Council Reference: DA11/0565.08 LN8987
Your Reference: MP08_0194 MOD 8

Development Application MP08_0194 MOD 8 (Council Reference DA11/0565.08) - amendment to Kings Forest Project Application)

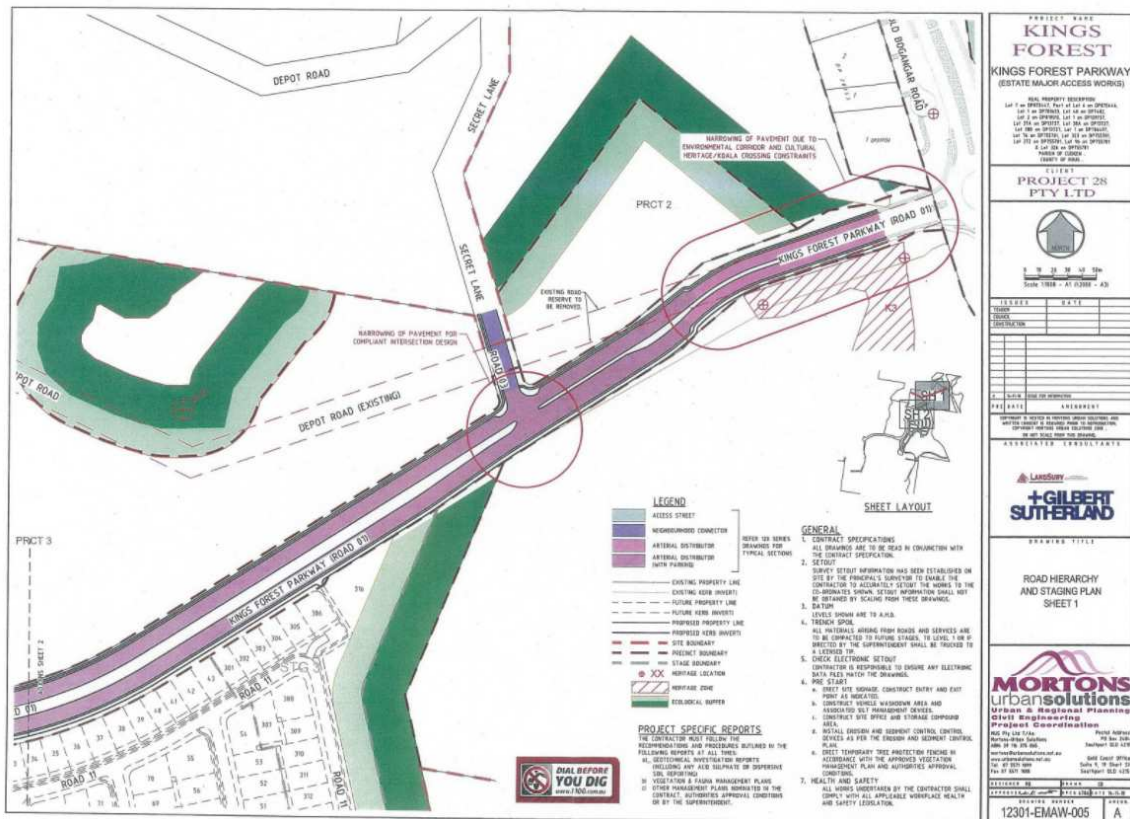
Request 3 – Amend Condition 23(6) relating to Kings Forest Parkway Road Pavement Width to less than 9m (7m) in certain locations as shown below:

Response 3: The revised condition wording as duplicated below is consistent with previous correspondence with Darryl Anderson and Mortons Urban Solutions.

- 23 (6) Kings Forest Parkway road carriageway is to be constructed to a minimum pavement width of 9m from the entry with Tweed Coast Road through to proposed Road 9, with the exception of those sections of Kings Forest Parkway, including intersections that conform with Austroads Standards, shown on Drawing No. 12301-SK-122, Amendment A, Morton Urban Solutions, 29 June 2018, and Road Hierarchy and Staging Plan, Drawing No. 12301-EMAW-005 and 006, Rev A – Mortons Urban Solutions which shall have a minimum pavement width of 7m. These details are to be provided on an application for a Construction Certificate."**

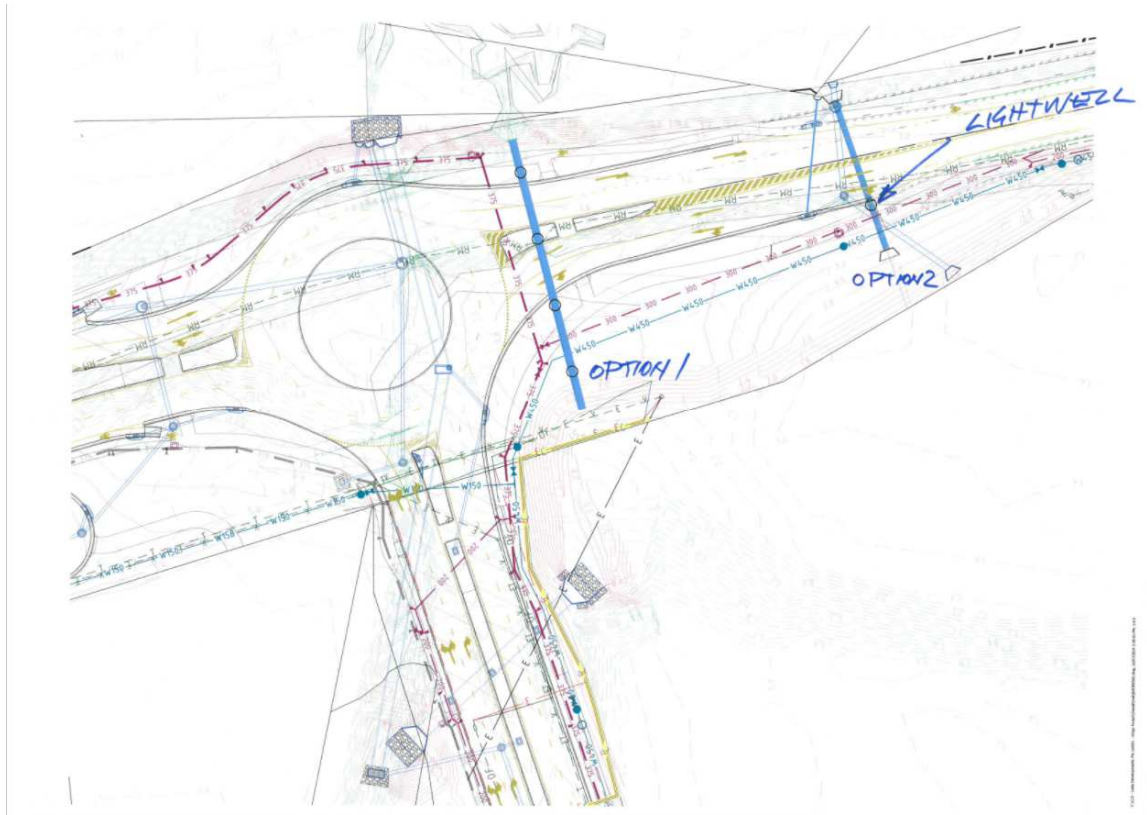
Council would also like the Department to be aware that Council is working closely with the applicant on the amended Koala Plan of Management and in these discussions the applicant is proposing to address the koala underpass across Tweed Coast Road further to the south of the proposed intersection (shown as Option B in the diagram below). Option 2 is considered to represent a good outcome and will replace earlier versions of the underpass through the round-a-bout. In relation to the

proposed underpass under the Kings Forest Parkway Council don't foresee any problems providing it is in the same general location and not longer than originally proposed.

These discussions will require Diagram 30(b) in the Koala Plan of Management (October 2018) to be updated to reflect these changes with the revised road widths and revised Koala underpasses.
